TI_2401: Adaptation of pump mount steam generator gas

iCombi Pro & iCombi Classic Gas 6-1/1
- 10-1/1 - 20-1/1

01.02.2024

Visual adjustment of steam generator

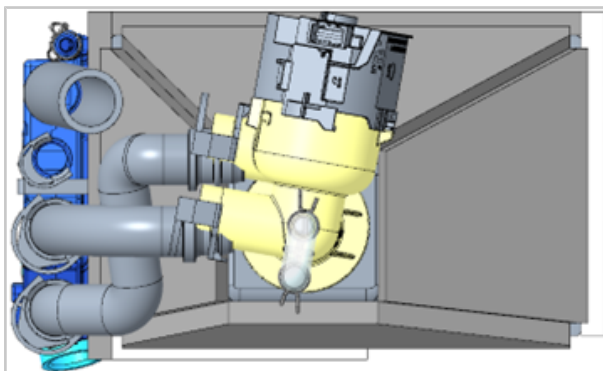
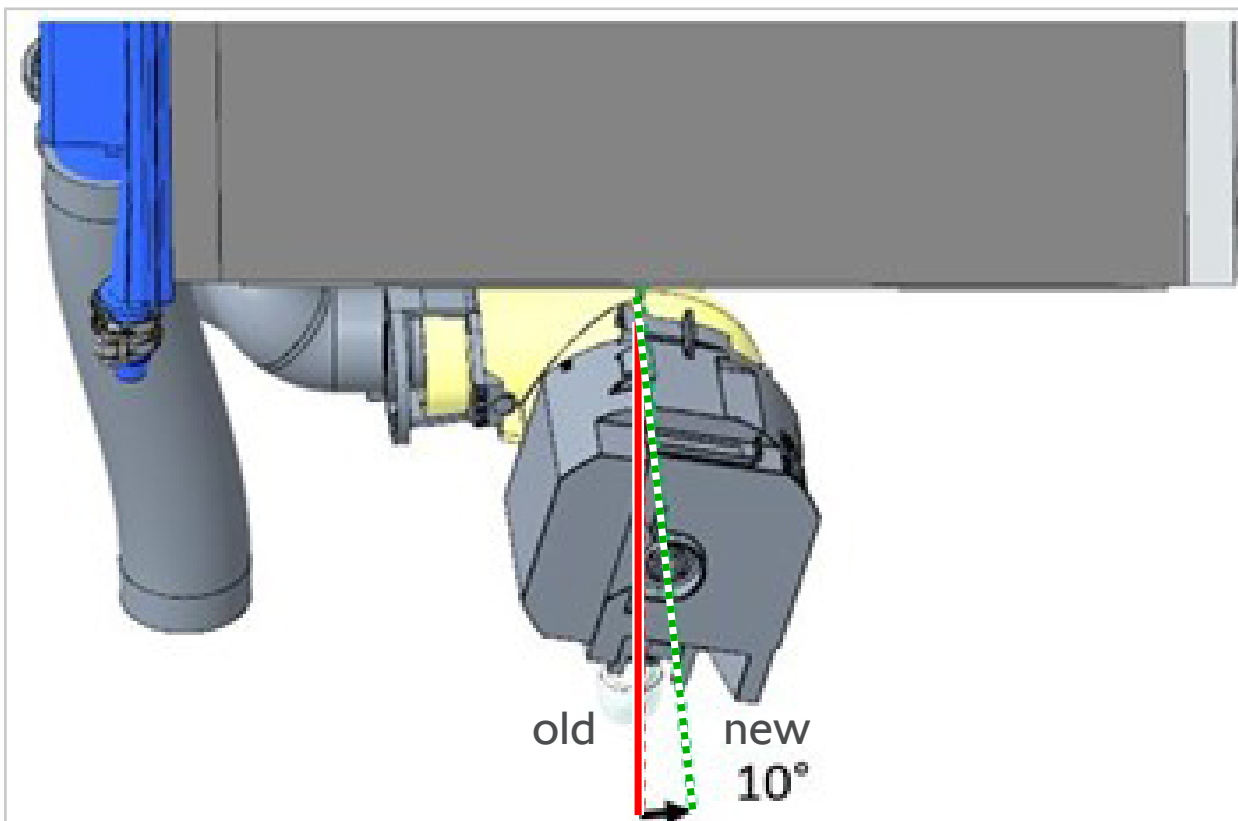
Due to the design adjustment of the steam generator, the pump housing is now rotated 10° less during installation.

This adjustment prevents the pump from coming into contact with other components and thus exerting pressure on the pump housing.

NOTICE! Always turn the housing until it reaches the end stop.
